# KING FARM

## SEVEN & EIGHT IRVINGTON CENTRE

### SITE PLAN

SEVEN / EIGHT IRVINGTON CENTRE, BLOCK M

#### PHASE 2 SITE PLAN

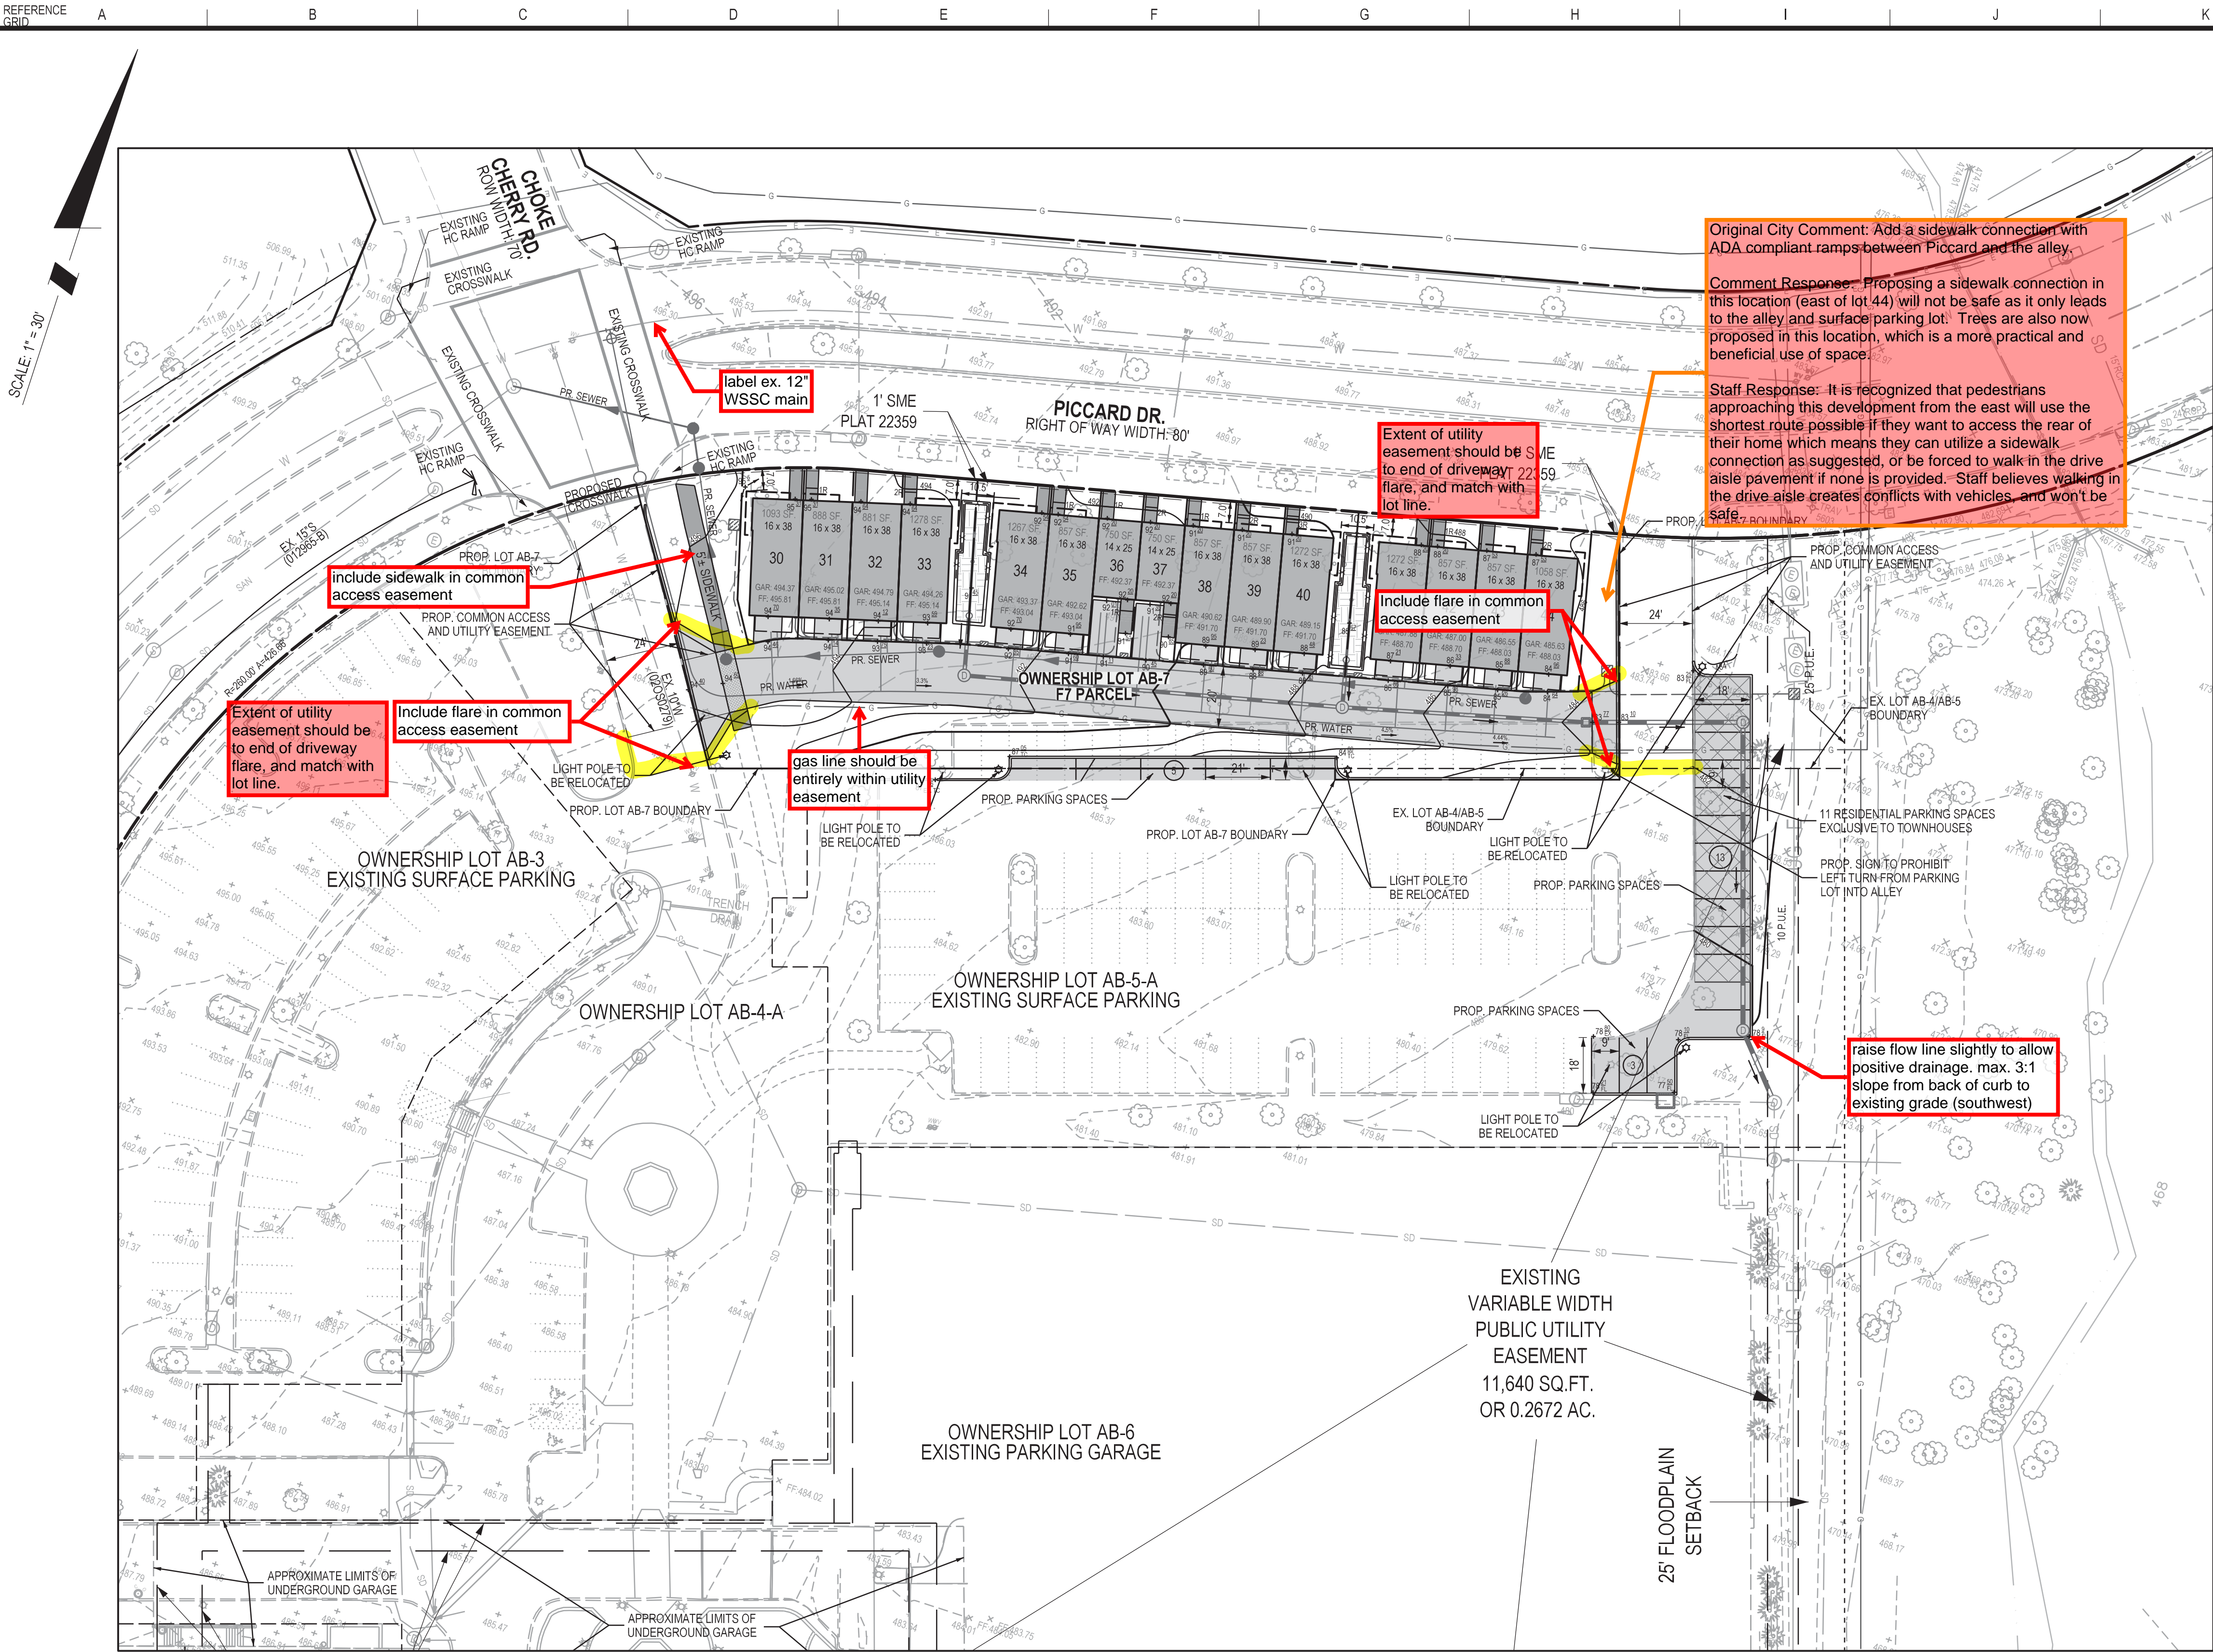
WSSC Requirements during Site Plan process:  
1. An Amendment to the previously approved HPA will also be required due to the location change. The HPA Amendment must be approved prior to City's approval of the Site Plan.

Original City Comment: Add a sidewalk connection with ADA compliant ramps between Piccard and the alley.

Staff Response: It is recognized that pedestrians approaching this development from the east will use the shortest route possible if they want to access the rear of their home which means they can utilize a sidewalk connection as suggested, or be forced to walk in the drive aisle pavement if none is provided. Staff believes walking in the drive aisle creates conflicts with vehicles, and won't be safe.

Extent of utility easement should be to end of driveway flare, and match with lot line.

Include flare in common access easement

raise flow line slightly to allow positive drainage, max. 3:1 slope from back of curb to existing grade (southwest)

Comment Response: Proposing a sidewalk connection in this location (east of lot 44) will not be safe as it only leads to the alley and surface parking lot. Trees are also now proposed in this location, which is a more practical and beneficial use of space.
